Addendum #1

Issued April 8, 2025

WESTDALE SECONDARY SCHOOL
HAMILTON - WENTWORTH DISTRICT SCHOOL BOARD
700 MAIN STREET WEST
HAMILTON, ONTARIO

ROOM FINISH SCHEDULE AND DETAILS

R26 LP-E is in Basement Corridor 009 near the Boiler room door. See below:

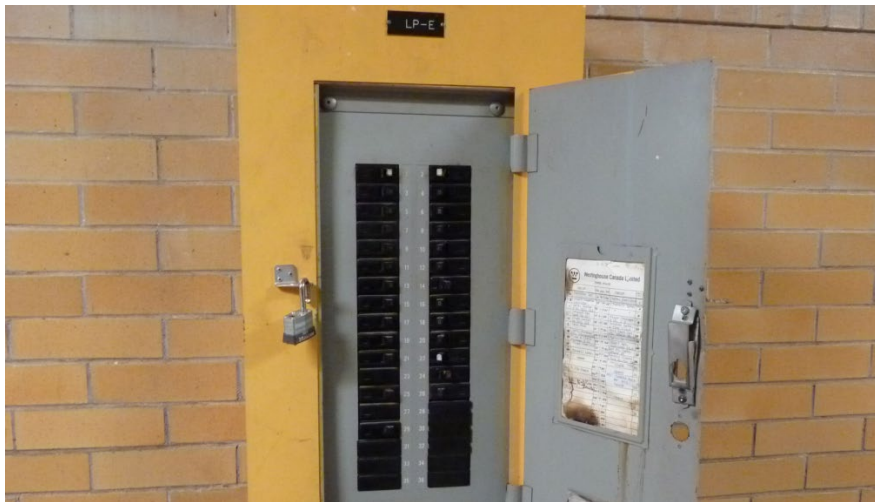
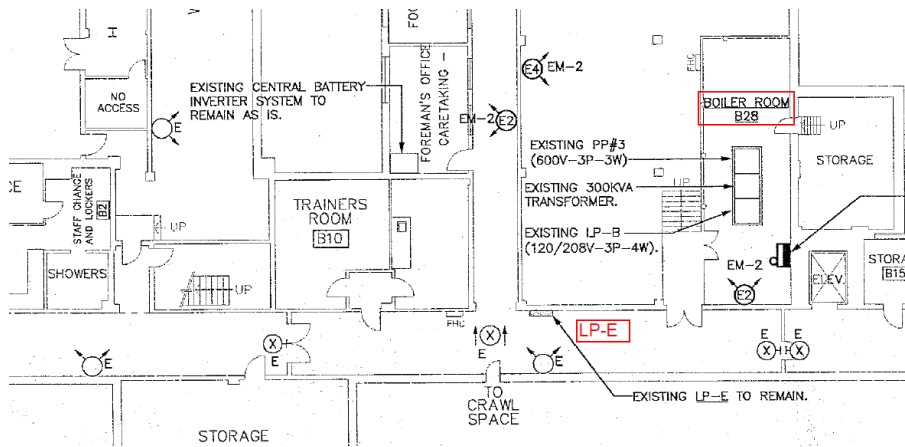
Q26 reference: Electrical Division 26 - Please provide Panel location for the following:
1. Location of Panel LP-E at Corridor - 009
2. Location of Boiler Room, another panel in there.

DRAWN BY:	CHECKED BY:
MS	RGB
DATE:	JOB No.:
FEBRUARY 2025	24-107
SCALE:	SHEET No.:
AS SHOWN	A4.02

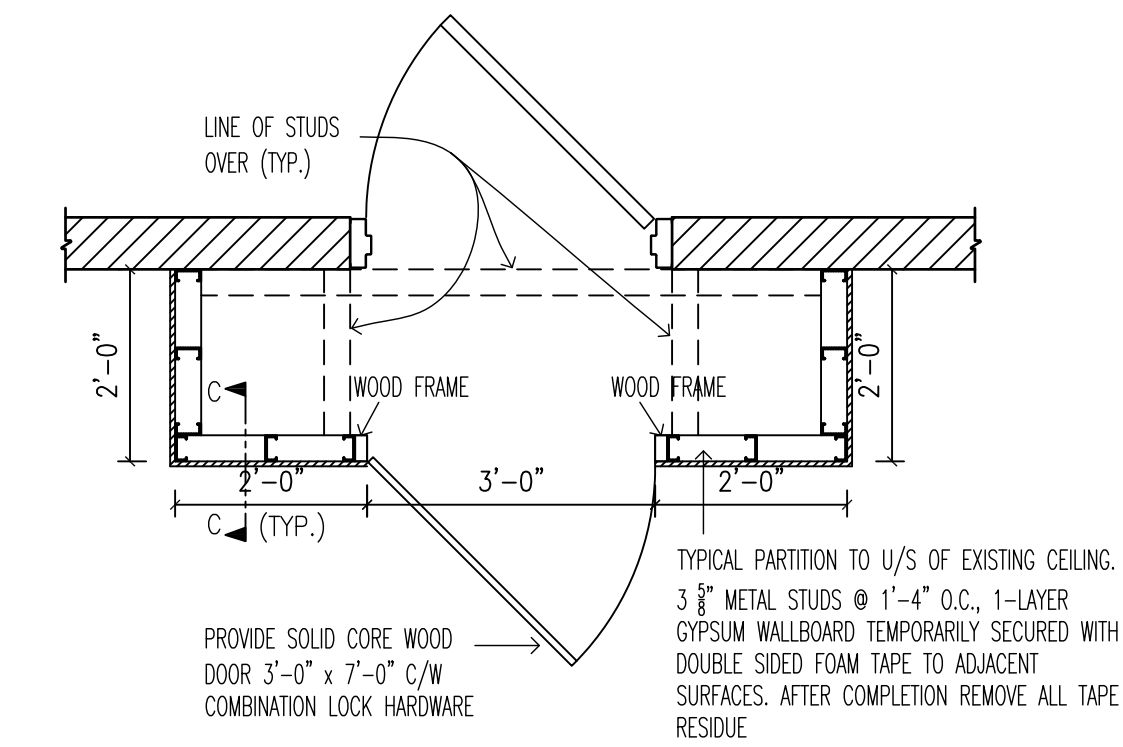
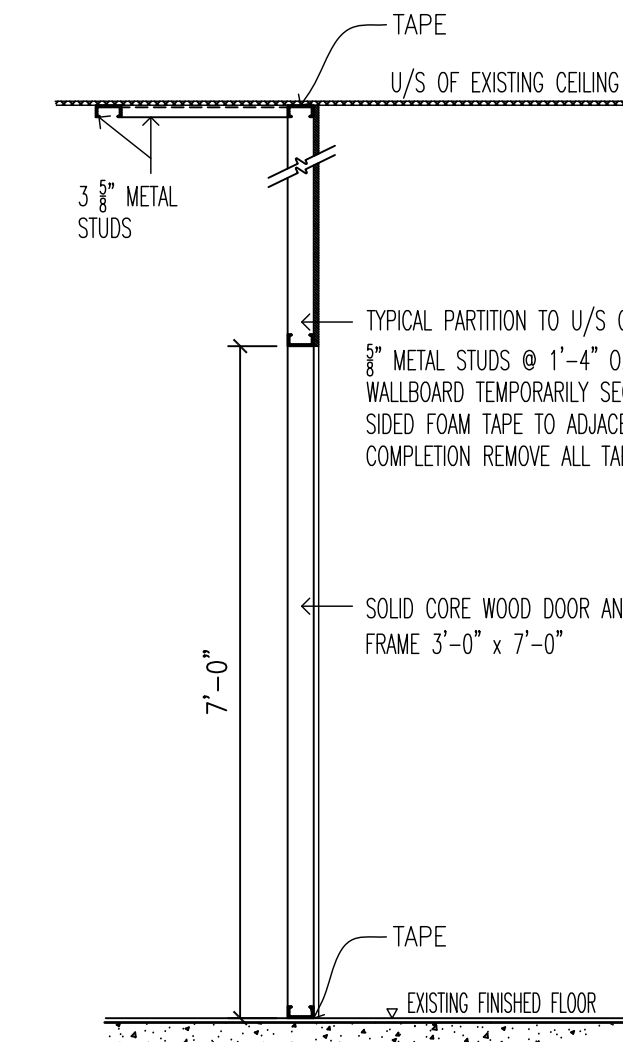
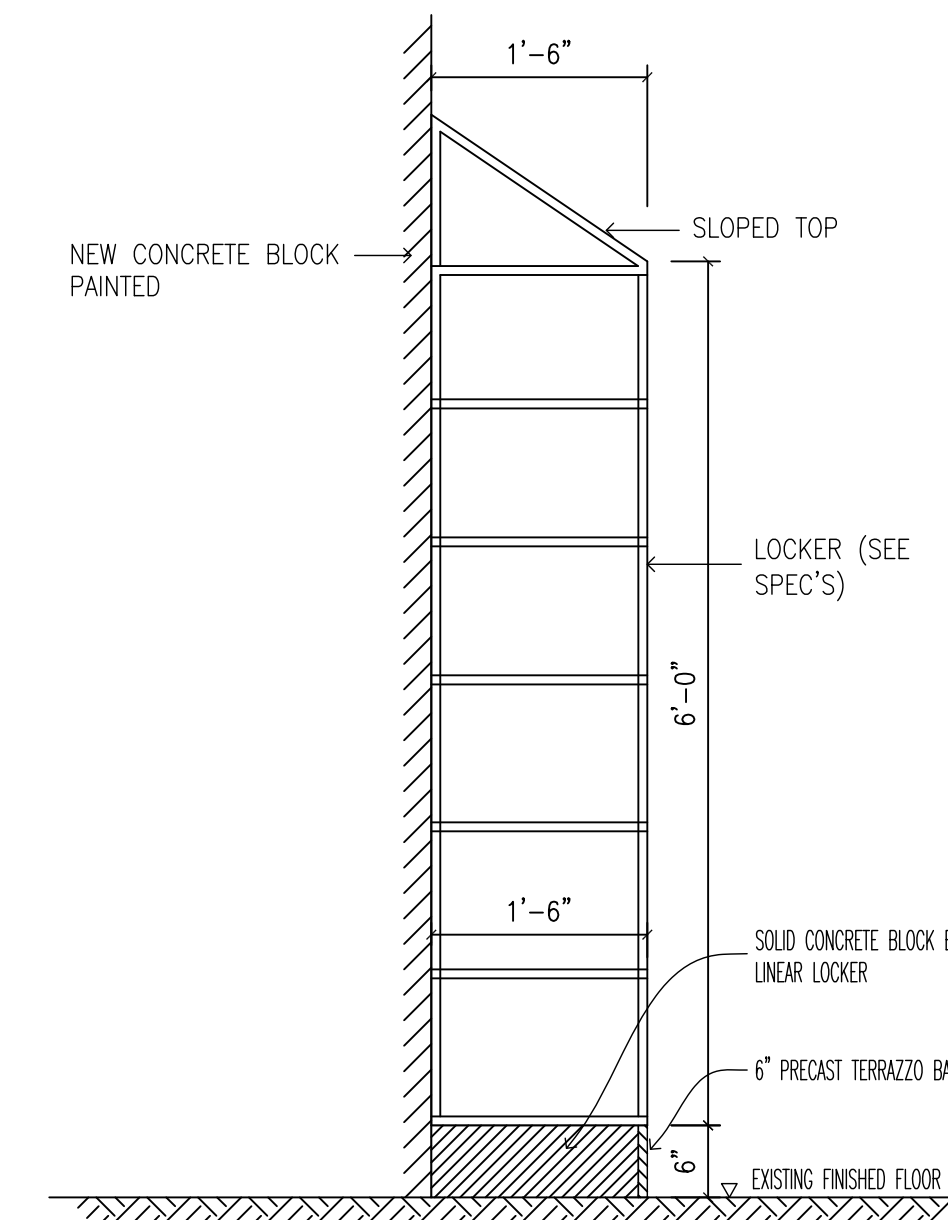
- Q11 The Reflected Ceiling Plan in A3.01 is not matching the Room Finish Schedule (i.e. 0003C is GWB Ceiling in RCP while it is Existing Concrete Paint in Finish Schedule). Please clarify.

- R11 **Remove and replace Drawing A4.02 with attached Addendum #1, A4.02 dated April 7, 2025.**
